Planning Commission
CITY HALL COUNCIL CHAMBERS
AGENDA OF NOVEMBER 12, 2024
7:00 PM

1. PPZ2024-0307 University Hospitals Urgent Care, 34548 Center Ridge Rd, PPN 07-00-016-101-054
Applicant: Madison Walkama, HSB Architects, 1250 Old River Rd, OH, 44113.
Proposal consists of constructing a 4,000 square foot urgent care building. Property is zoned B-3 Highway Commercial District.

Planning Review

Planning Commission Comment Sheet

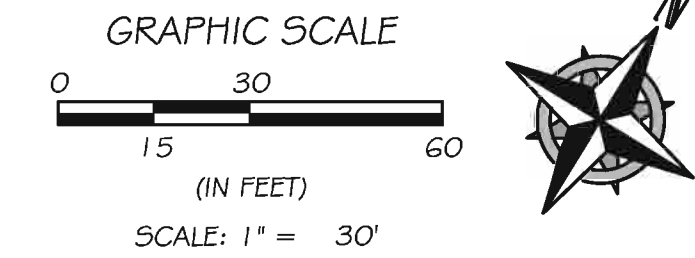
Brent discussed page C1.0 that showed the existing condition of the site including the former Scooter's that was built about two years ago next to the car wash. He stated that the entire site was built up ready for the future development of the parcel. Sheet C2.0 showed the overall site of the new UH facility building and the parking in the back. He added that all of the utilities had been stubbed out for that parcel to be improved along with the sanitary and water being the only thing that they would need to bring in another tap for. He explained that the storm water was also taken care of via the existing retention basin towards the rear of the property. Brent said the calculations for any of the impervious surfaces had already been taken care of. He said the permanent storm water quality management designs had been updated to include that the catch basins were cleaned as part of the regular maintenance.

SHEET: **C2.0**

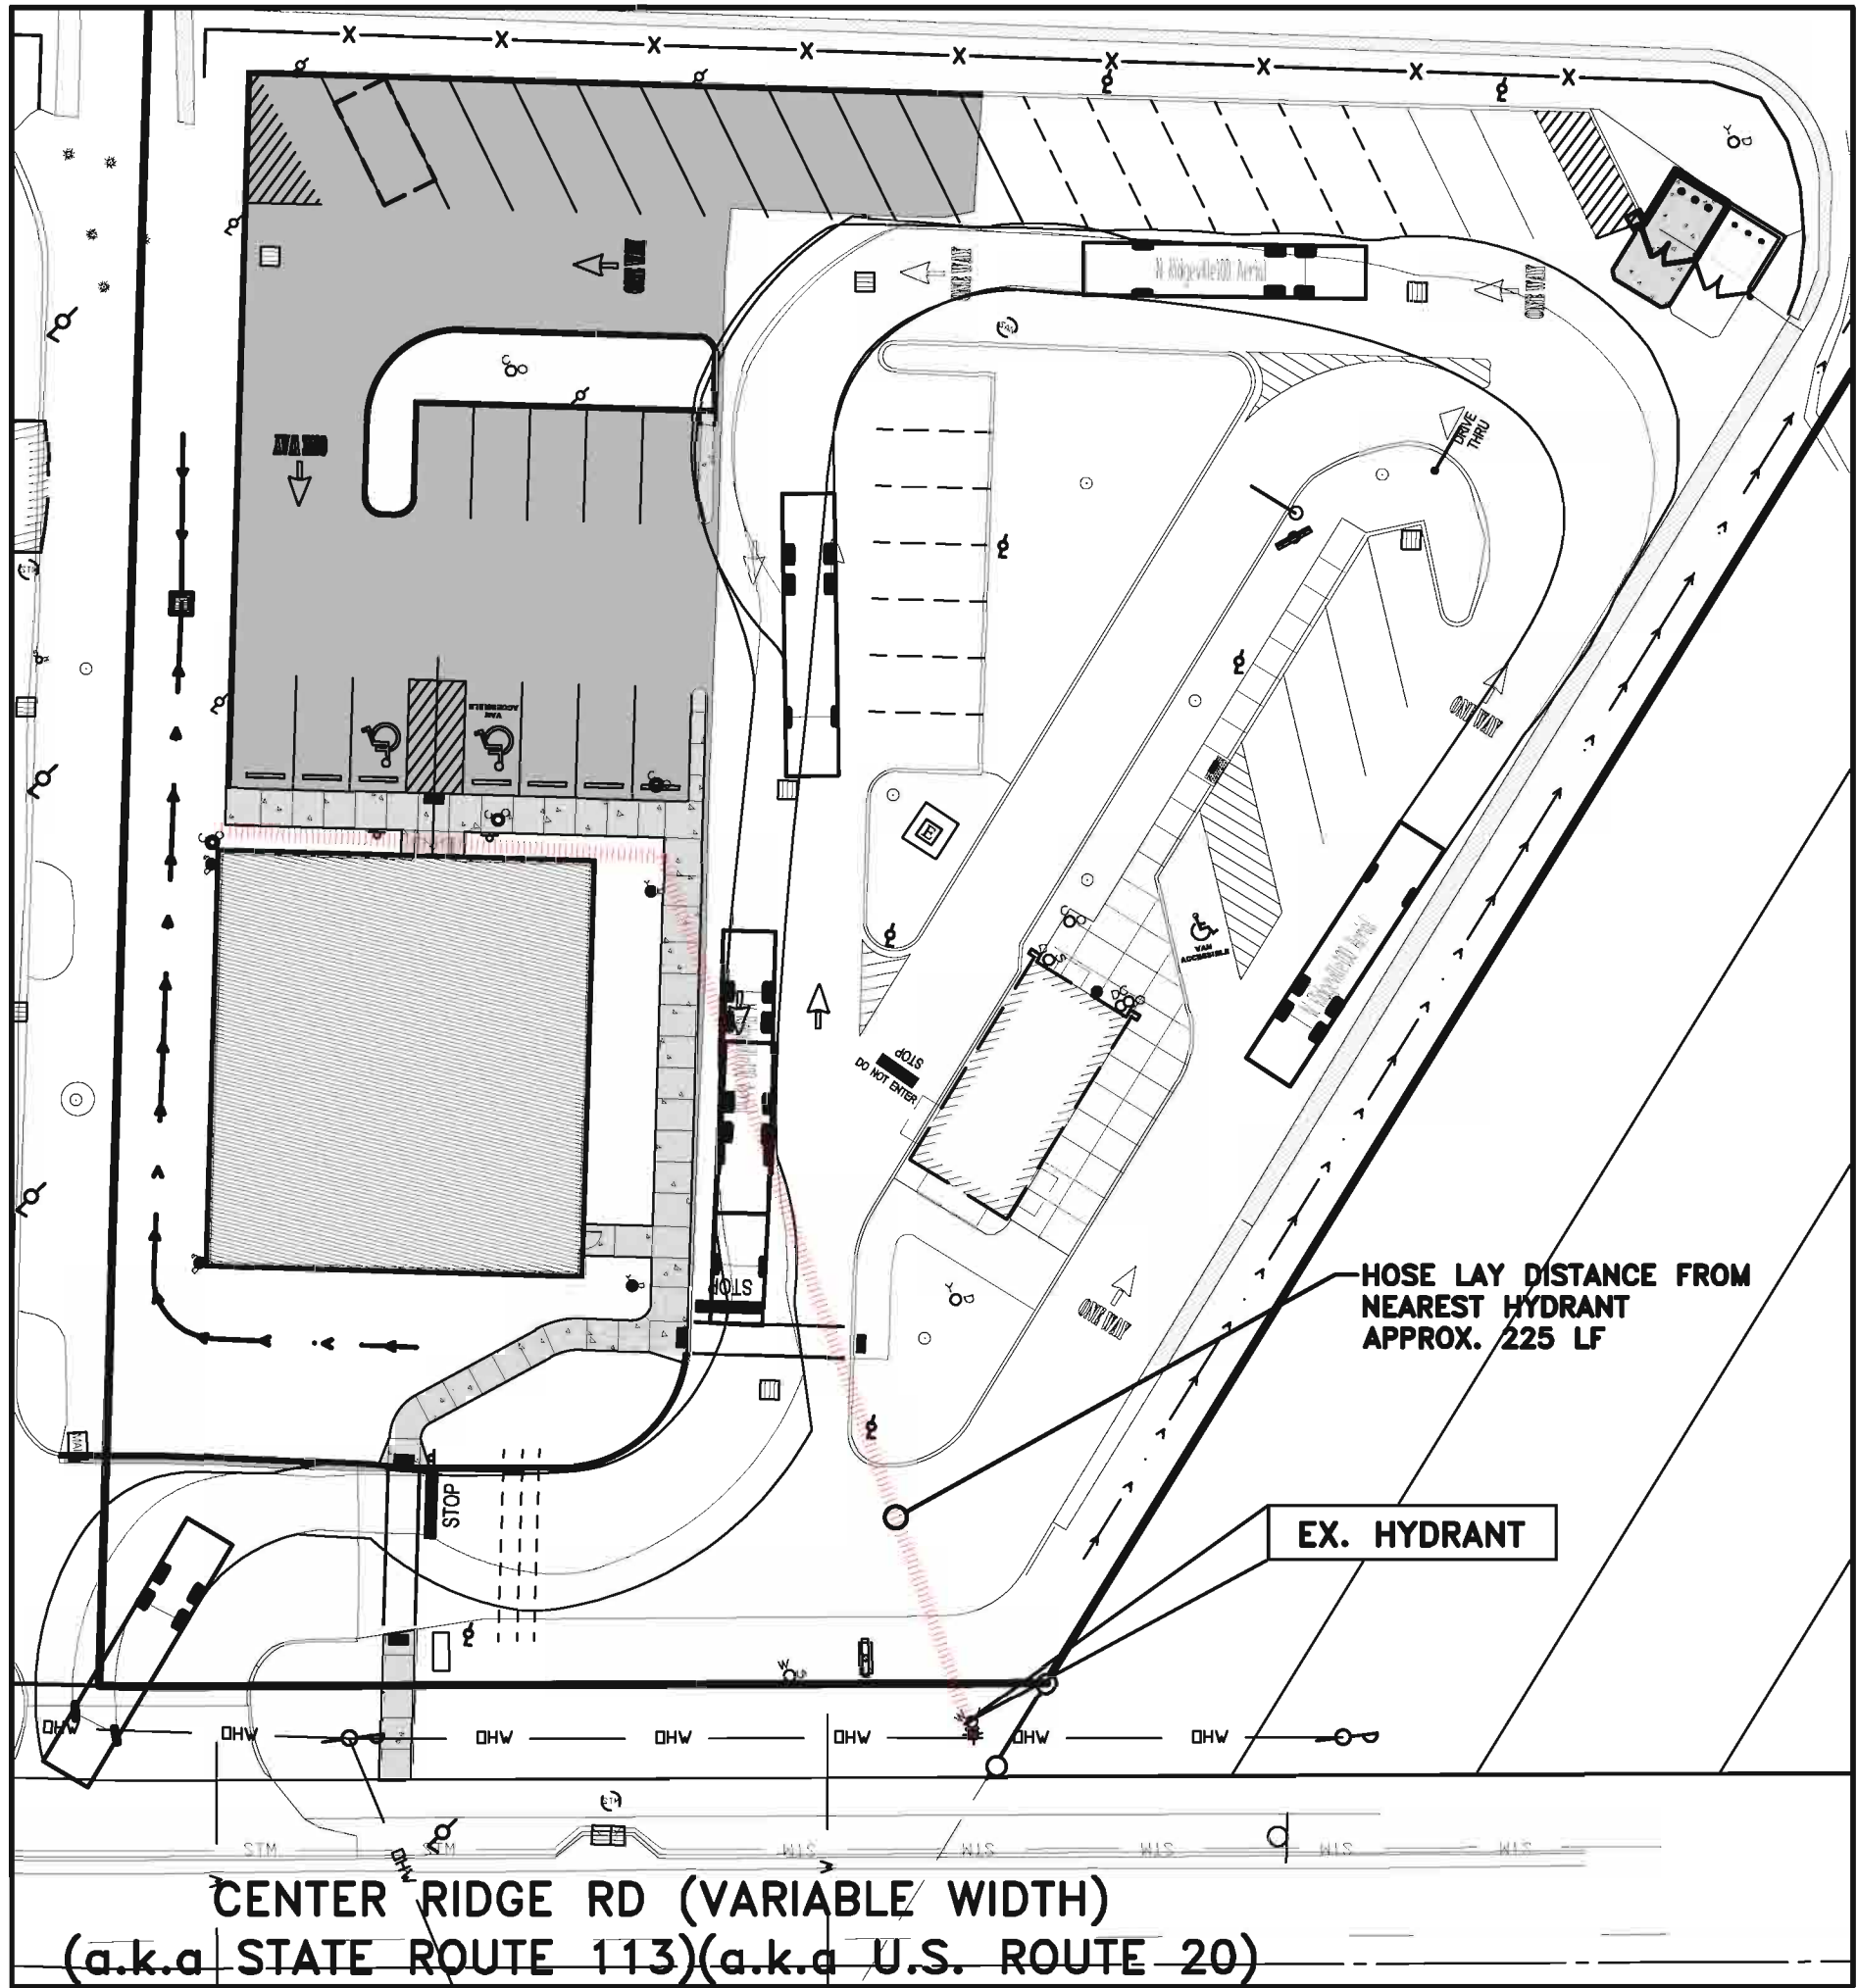
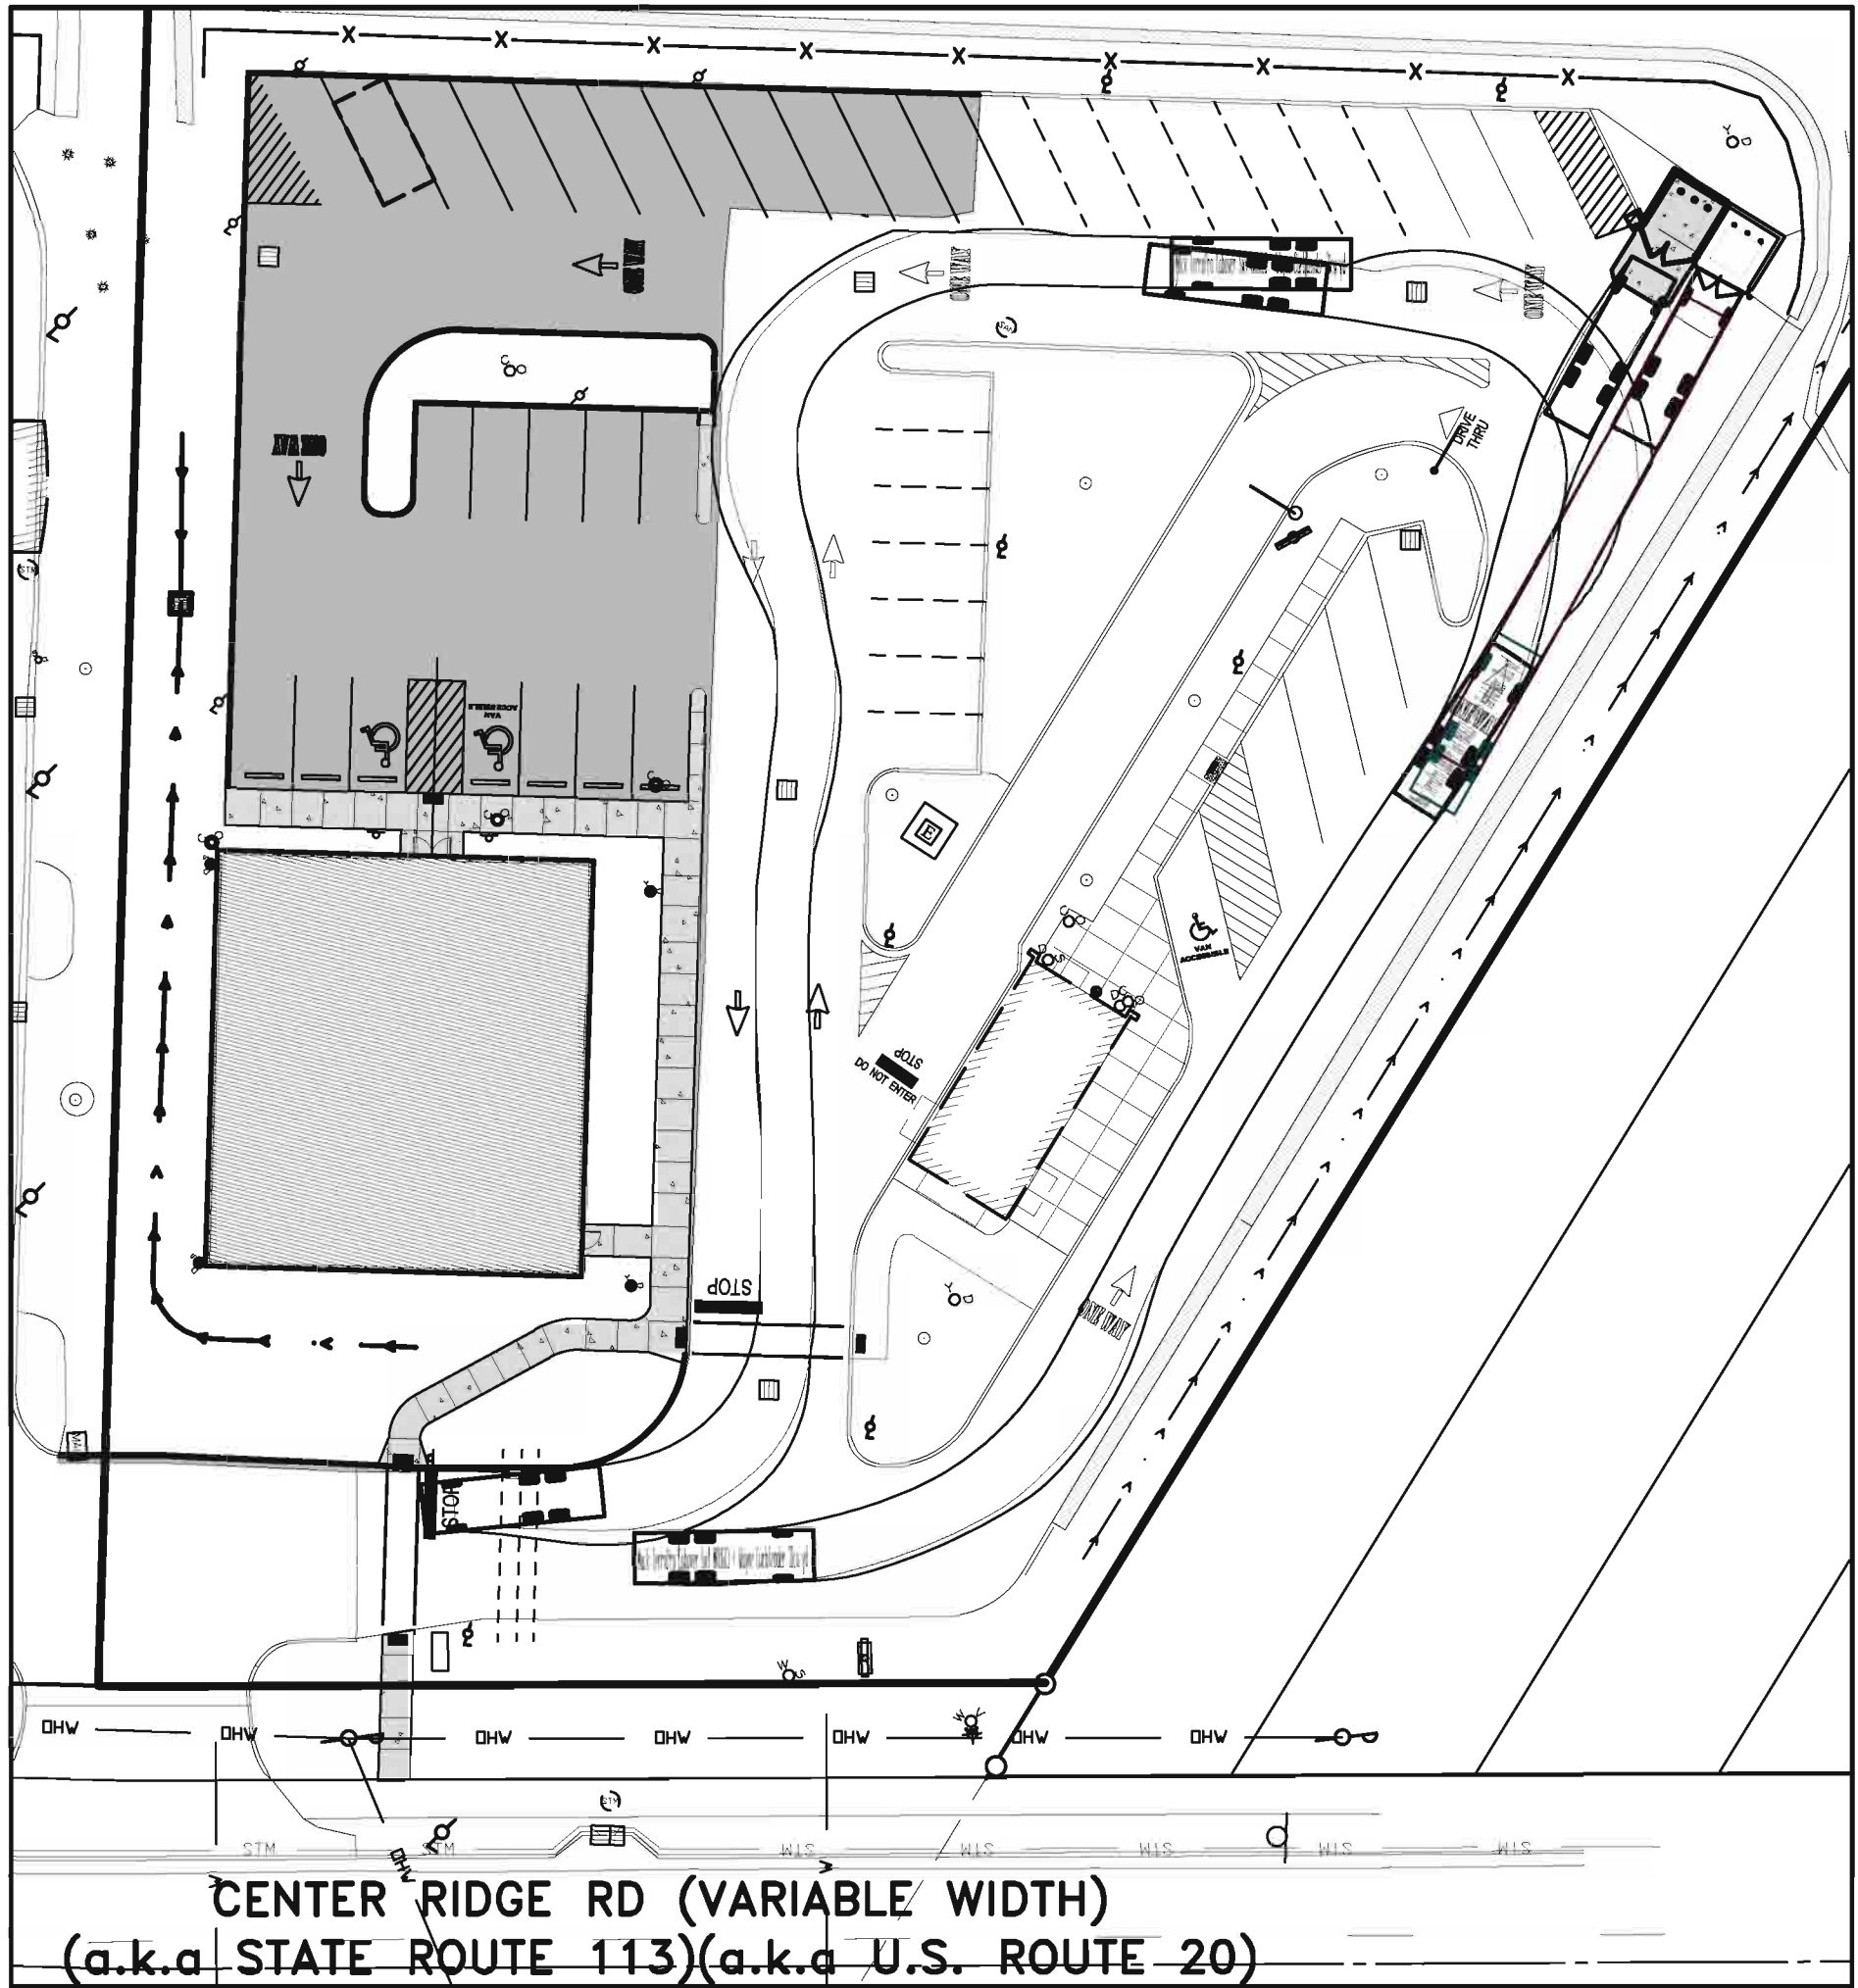
Brent said the dumpster location was going where Scooter's was and that they were looking to add on just another single stall, essentially a dumpster pad up in that particular area. He indicated that they received a few comments from Kim regarding a front set back that may be a little bit greater than what was required now on the site. He mentioned that the other item was the turning radius of the fire trucks, and that they did try to put those in there as best they could with the auto term program. He stated that the front bumper was hanging over the one landscape area just a little bit, which was page C2.1, in the upper left-hand corner, and he thought if the vehicle traveled slowly, they could make the turn with just the overhang of the truck over the landscape island.
